Town of Jericho  
Jericho Development Review Board

RE: 368 VT Route 15 amend a previously approved subdivision

RE: 368 VT Route 15 site plan review for the construction of a 7,015 sq. ft multi-use building to be located on lots 2B & 2C.

Re: Tatro 368 VT Route 15 Properties, LLC, Subdivision and Multi-Purpose Building Site Plan

Drawing title:  
 Elevations

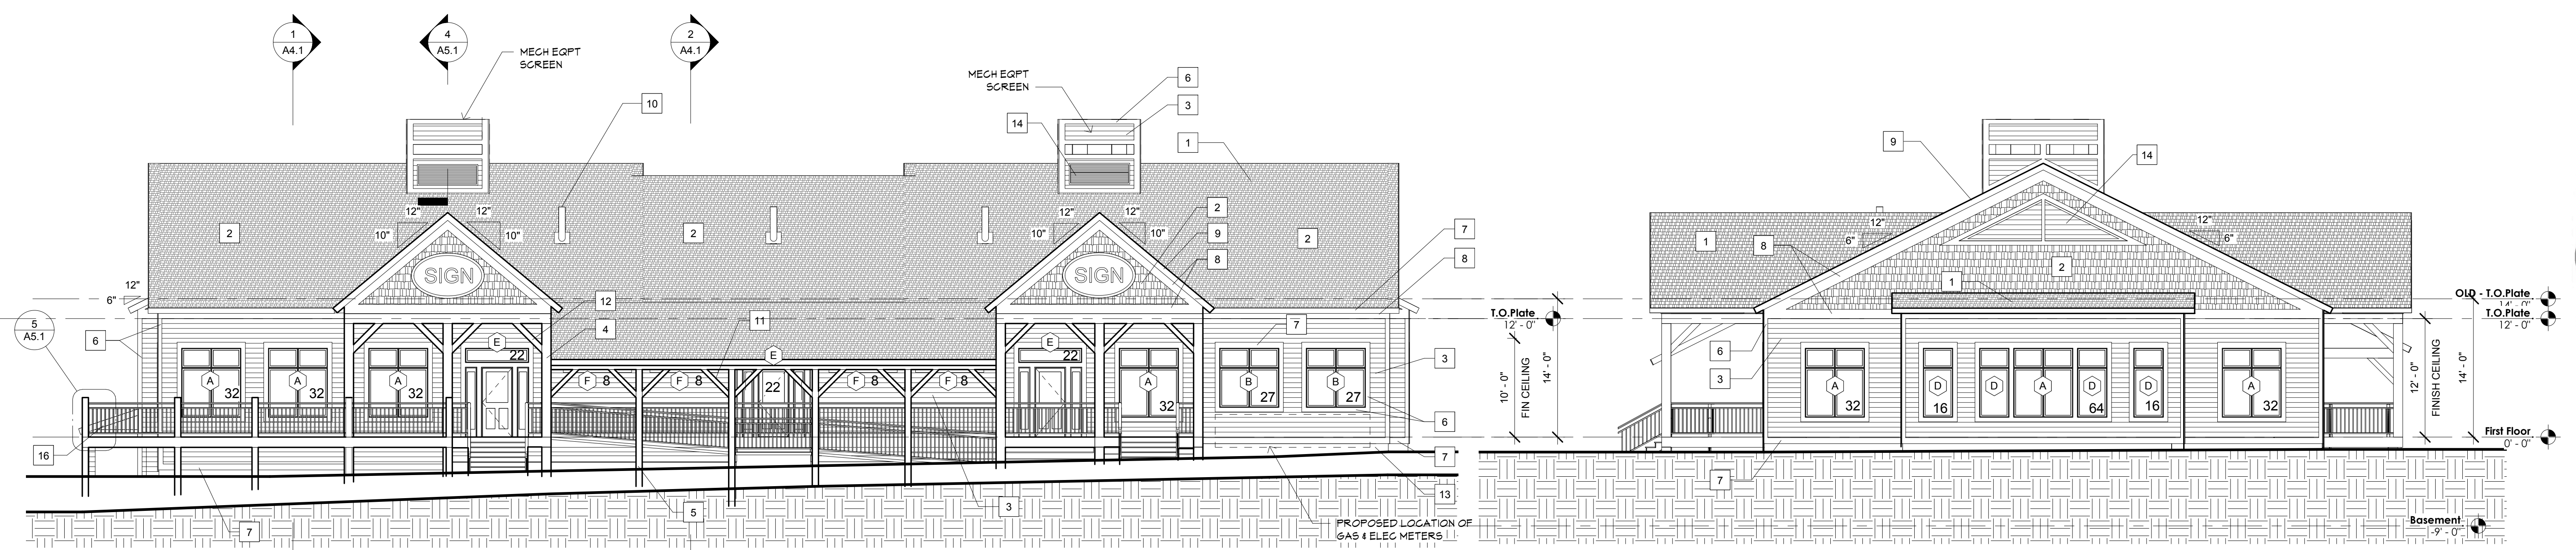
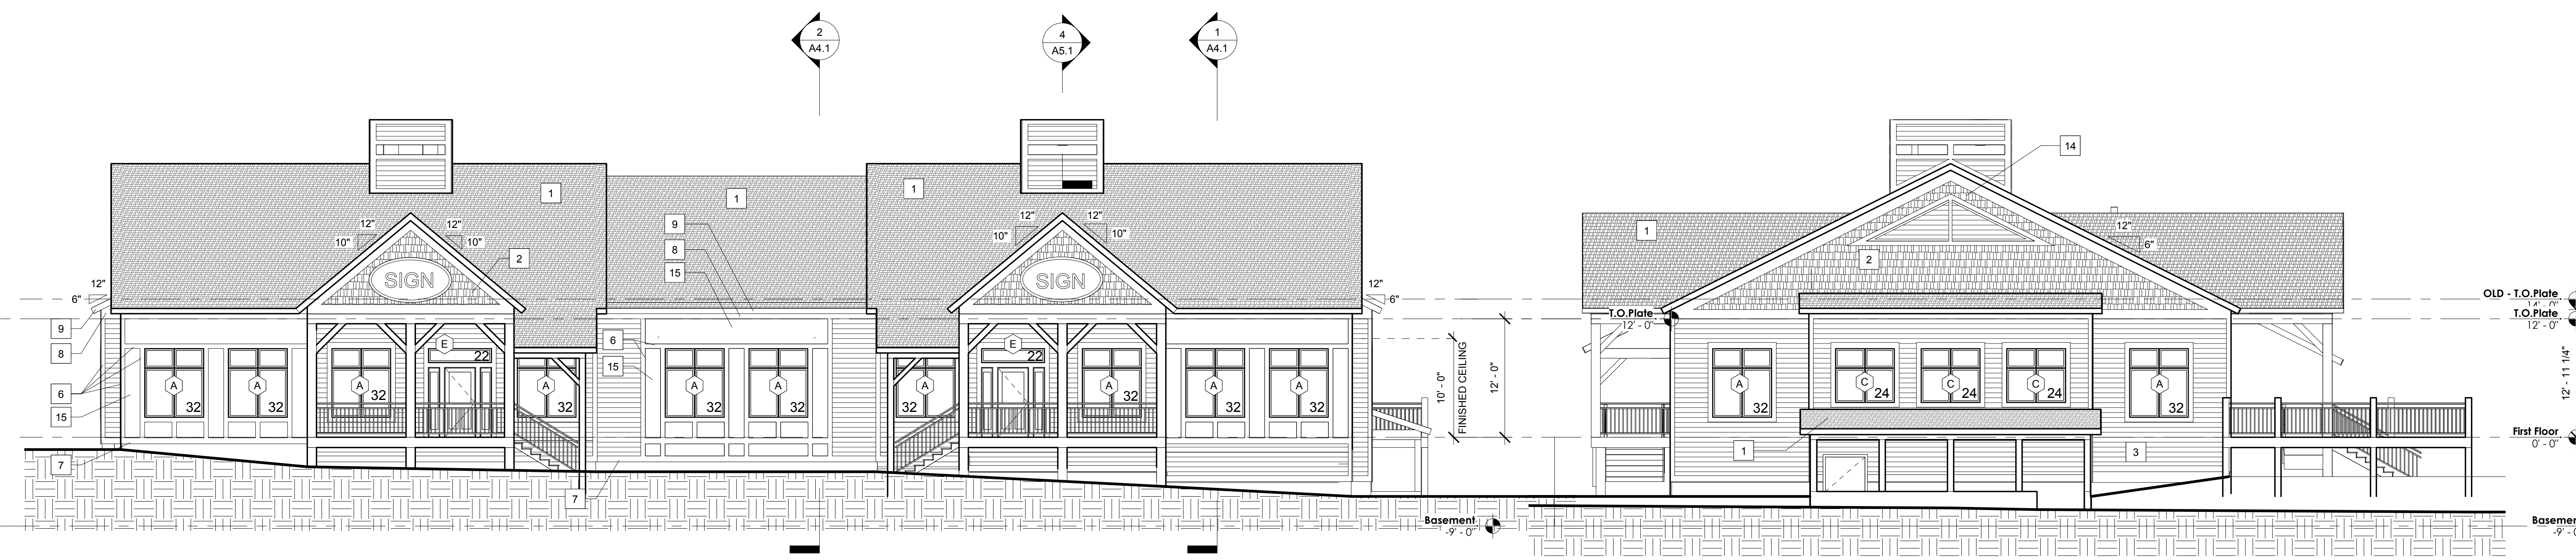
The east façade does not comply. The plan shows a 4’ recess 58 feet from either end. The east façade is not the principal frontage but it faces the main parking area for the building.
